CITY OF KEY WEST

ADDENDUM NO. 1 CAROLINE STREET IMPROVEMENTS / ITB 15-007

This addendum is issued as supplemental information to the bid package for clarification or amending of certain matters of both a general and a technical nature. The referenced Invitation to Bid (ITB) package is hereby addended in accordance with the following items:

JOB NO.	111008
DRAWN	BDH
DESIGNED	RQY
CHECKED	RQY
QC	
SHEET	E-2

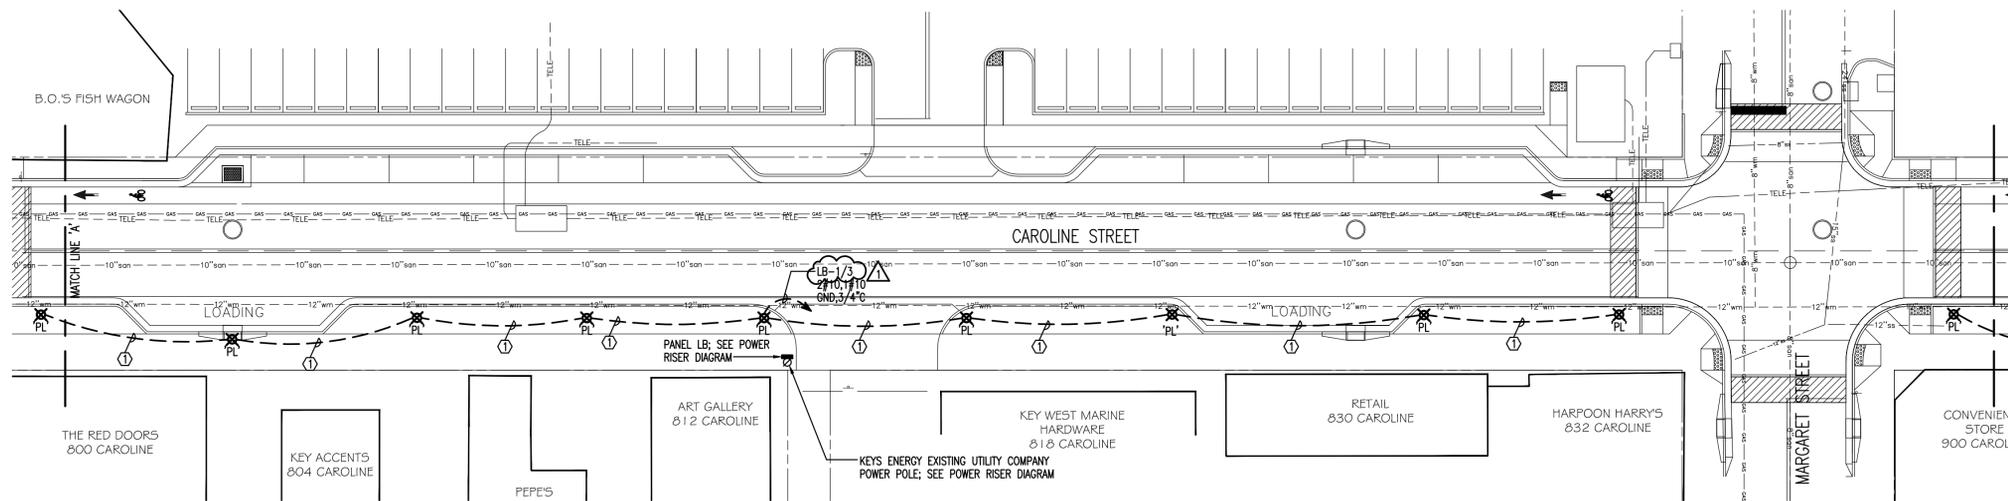
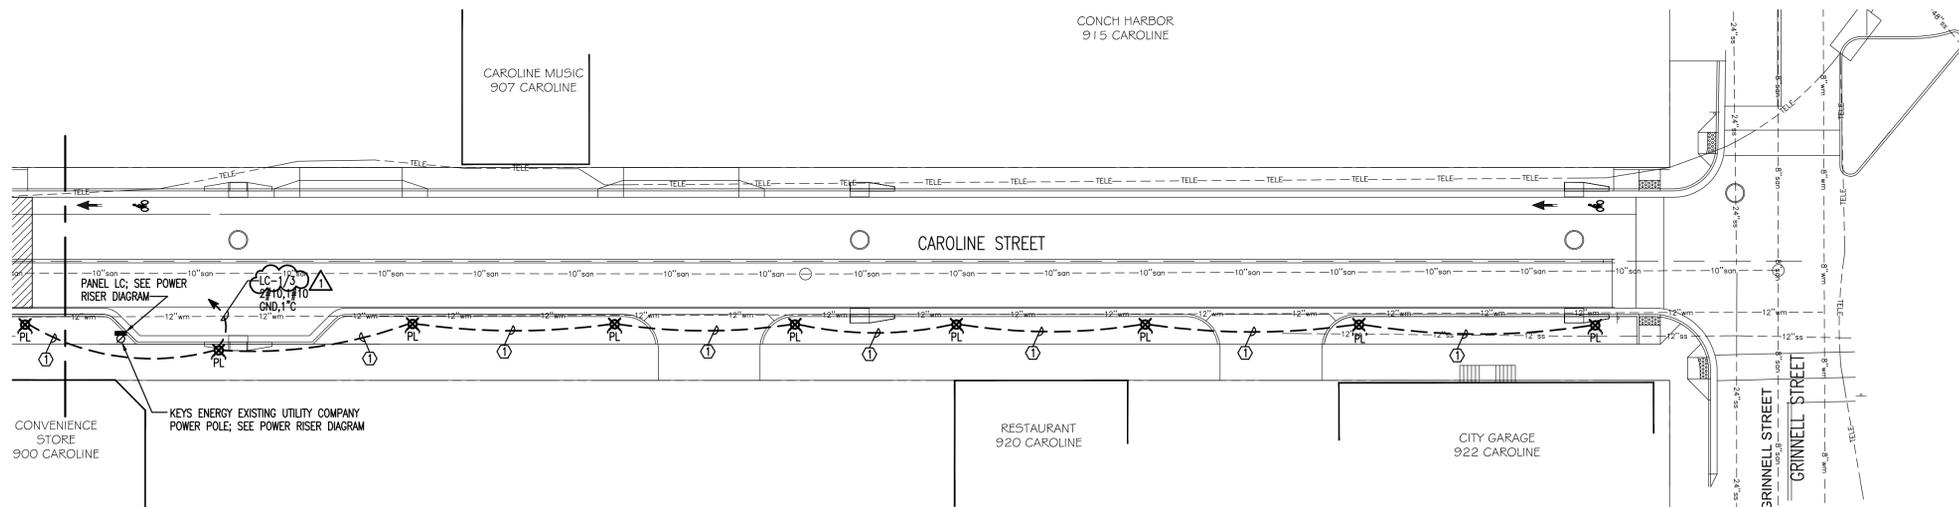
<u>Sheet(s)</u>	<u>Description</u>
E-2	LIGHTING PLAN – Corrected “Key Note” to revise lighting circuits to be 2-pole.
C-5	ROADWAY – Lengthened loading zone at approximately STA 8+45 to 72 feet
C-9	DRAINAGE PLAN AND PROFILE – Provided clarification of grading for Parking Garage ramp at approximately STA 13+28
C-10	SIGNING AND PAVEMENT MARKING PLAN – Revision of Loading Zone and Parking Space signage and striping locations and details
C-11	SIGNING AND PAVEMENT MARKING PLAN – Revision of Loading Zone and Parking Space signage and striping locations and details
C-19	PARKING LOT PLAN – Revision to add two (2) pedestrian access/egress points along proposed fence line, 5 feet wide each with steps as applicable.

DRAINAGE PLAN & PROFILE

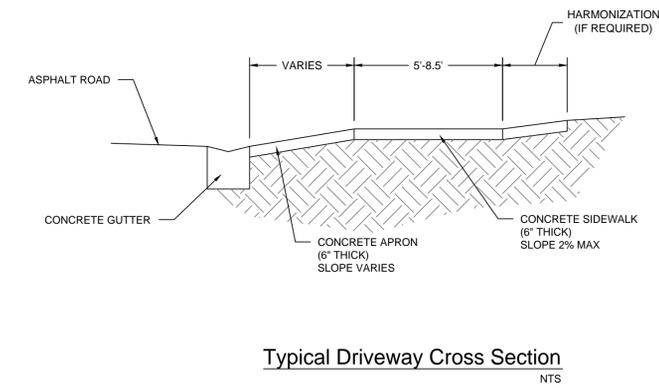
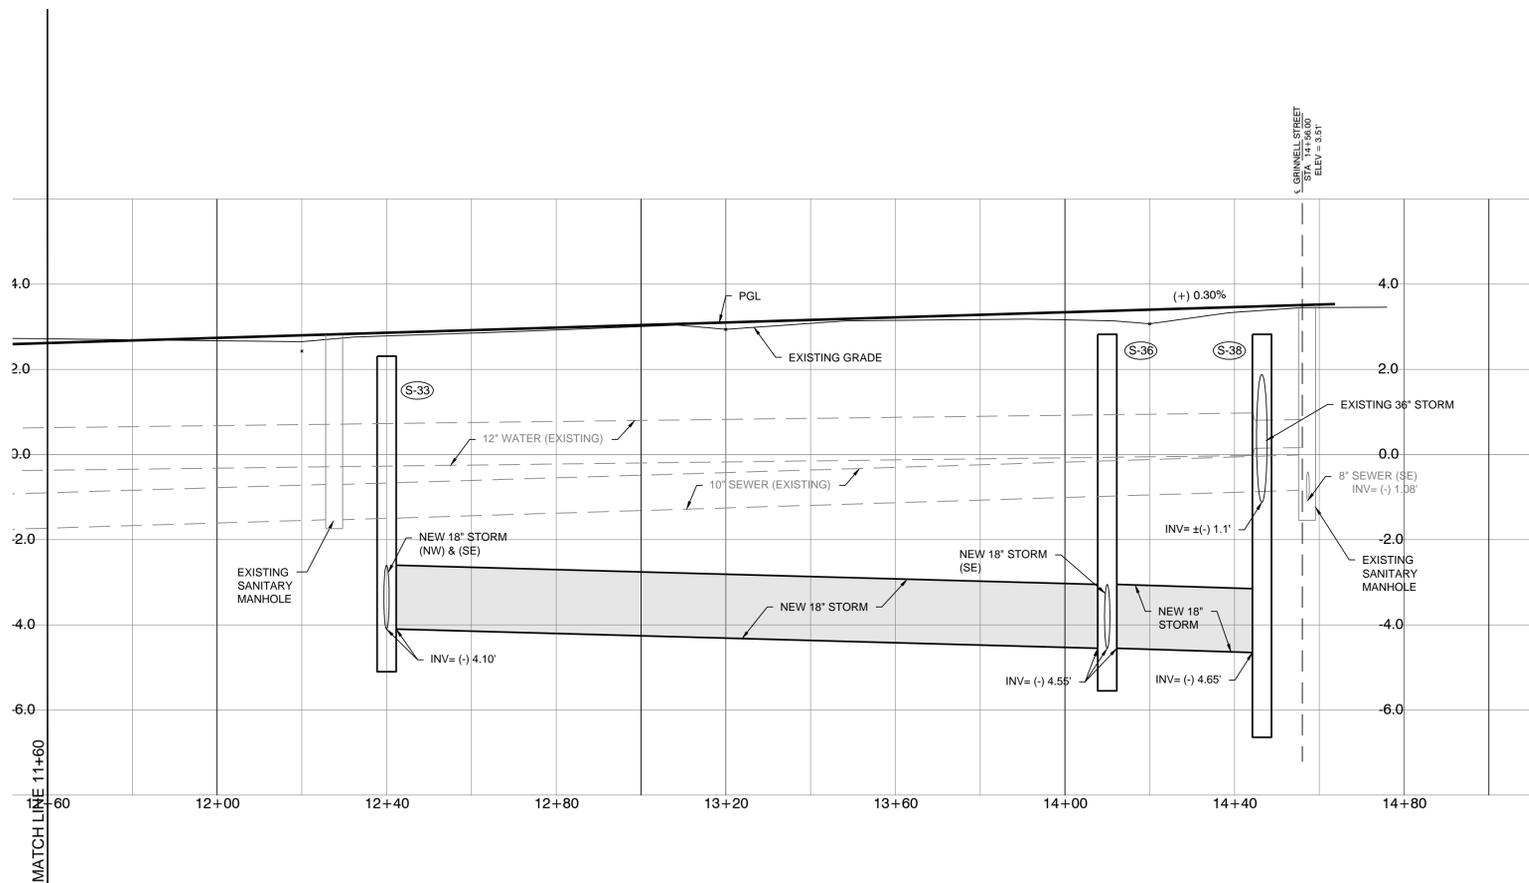
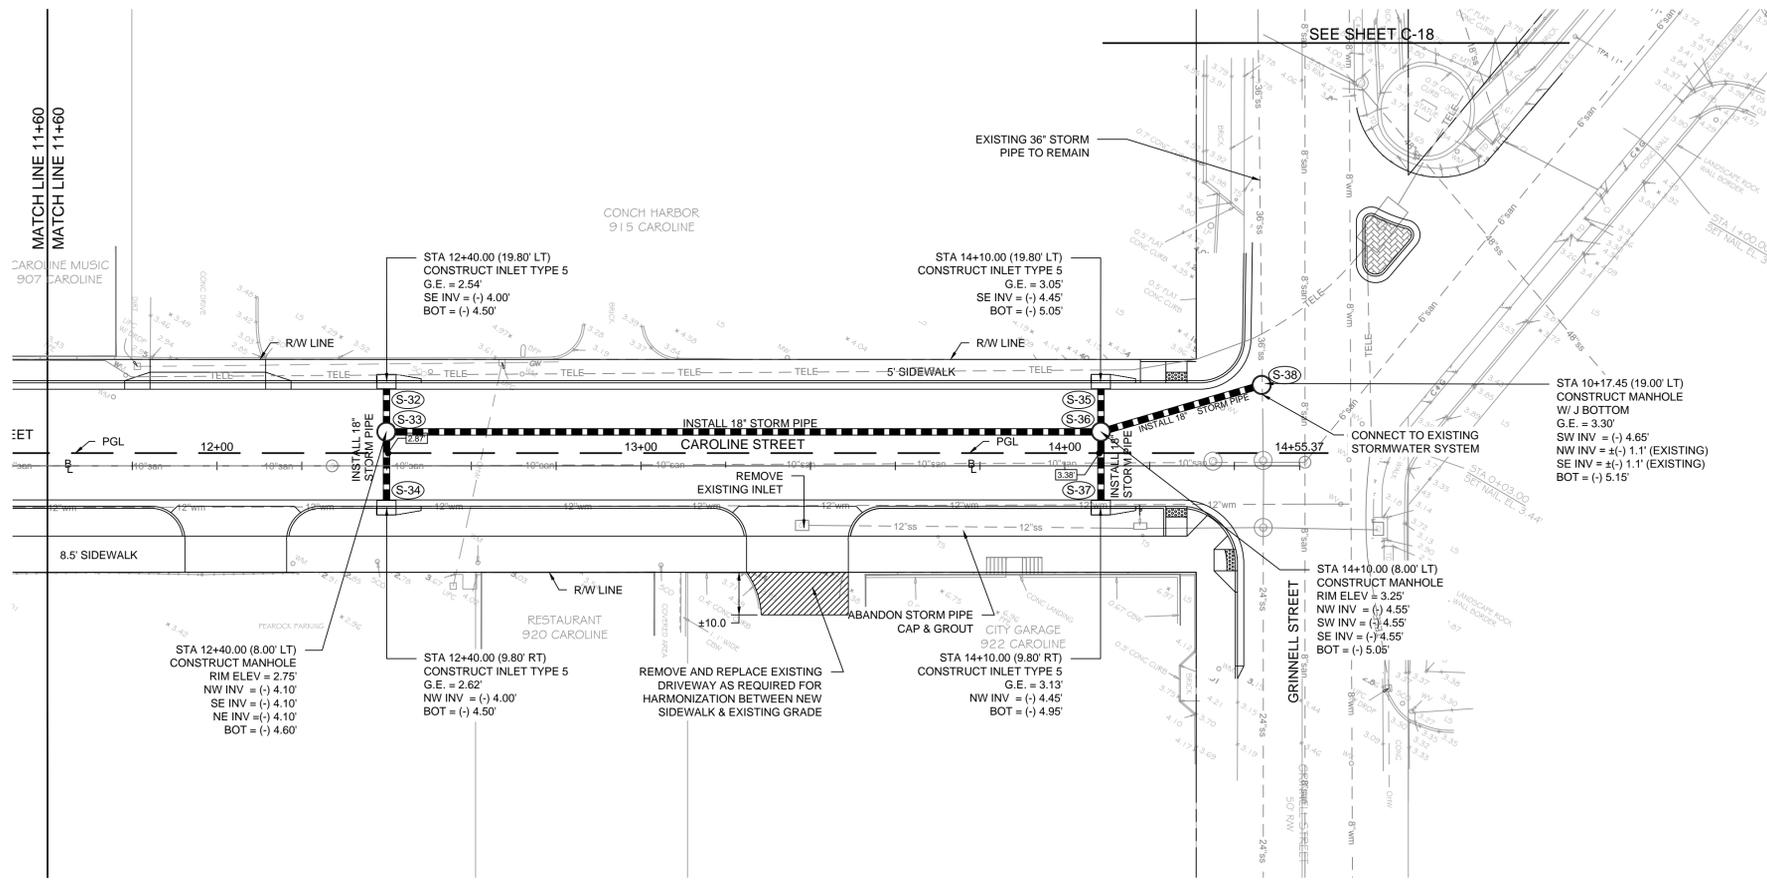
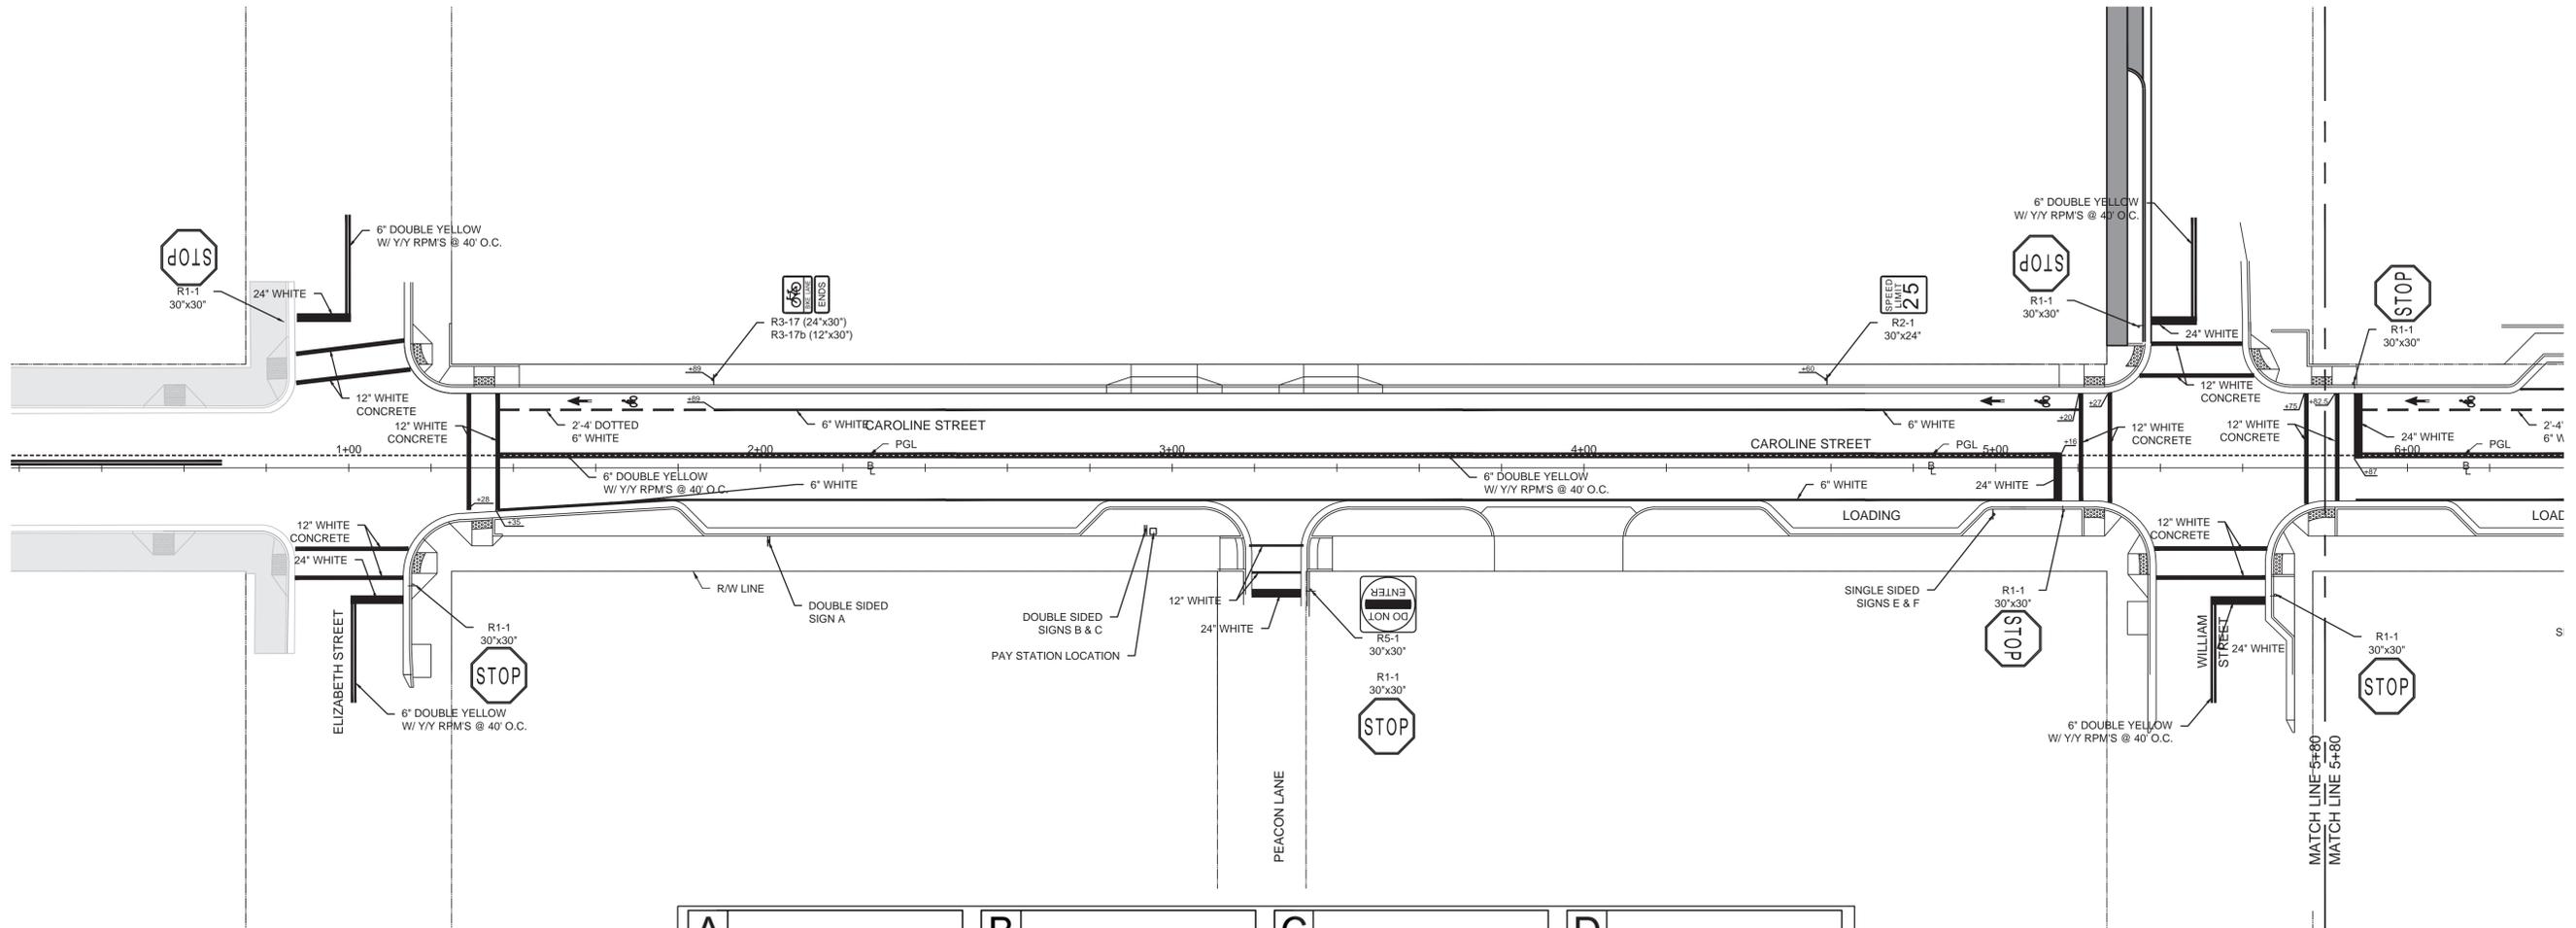
2. Parking Garage driveway replacement/transition on Caroline Street has been described on Sheet C-9 which is attached
3. Bus Parking Area / Sheet C-1 Caroline Street Parking Lot – 900 Block will be issued in Addendum 2 the week of June 22, 2015

C-11

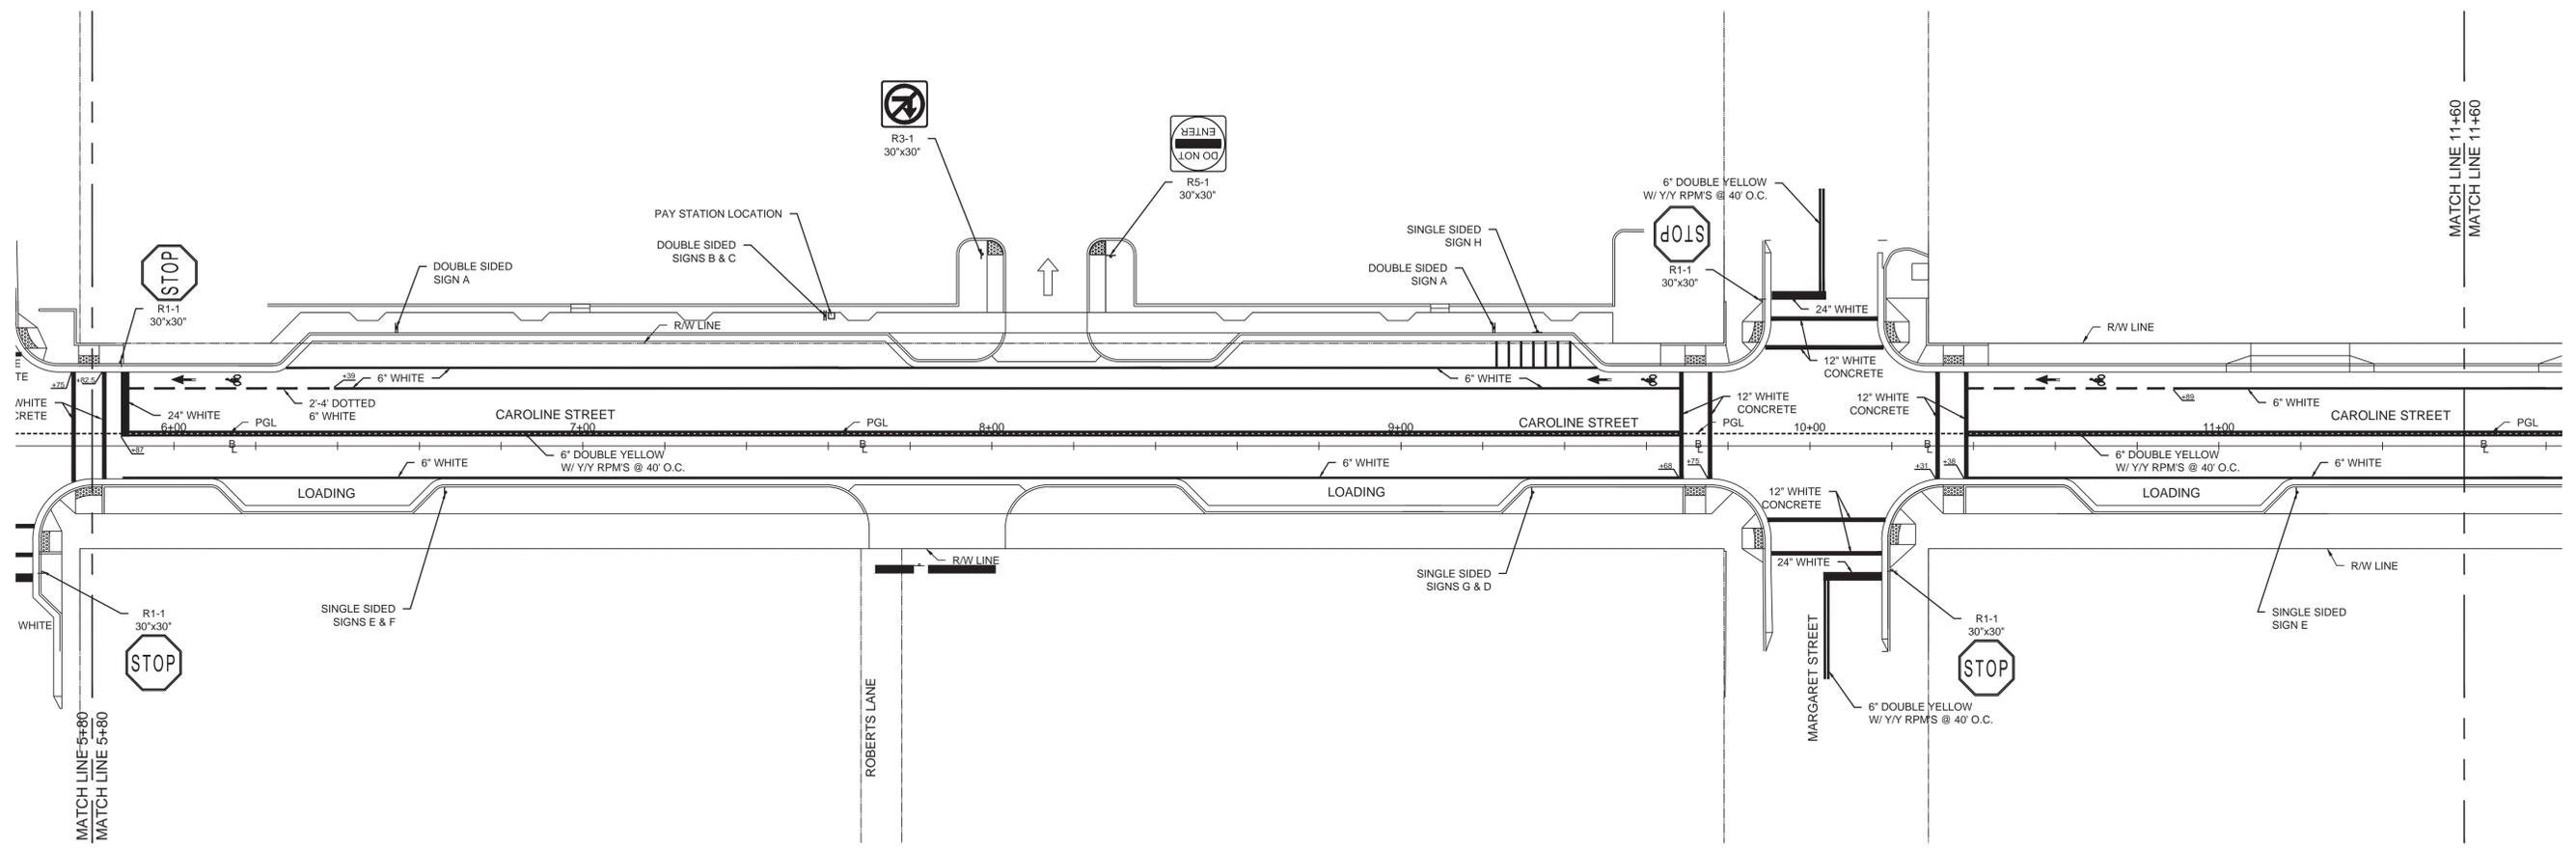
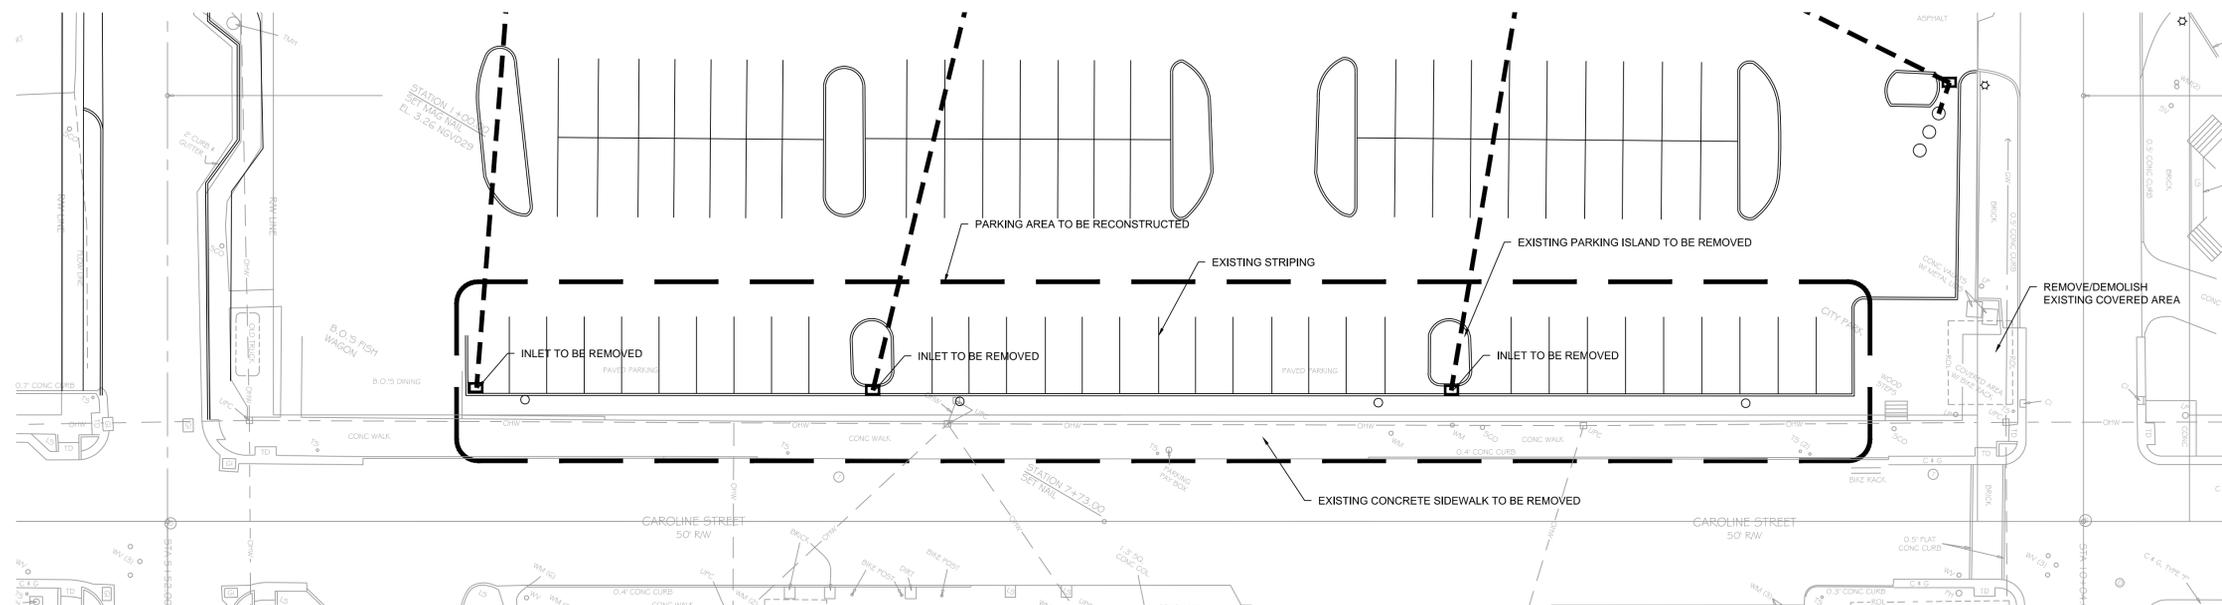
4. Signage Plan has been amended as indicated on Sheets C-10 and C-11 which are attached
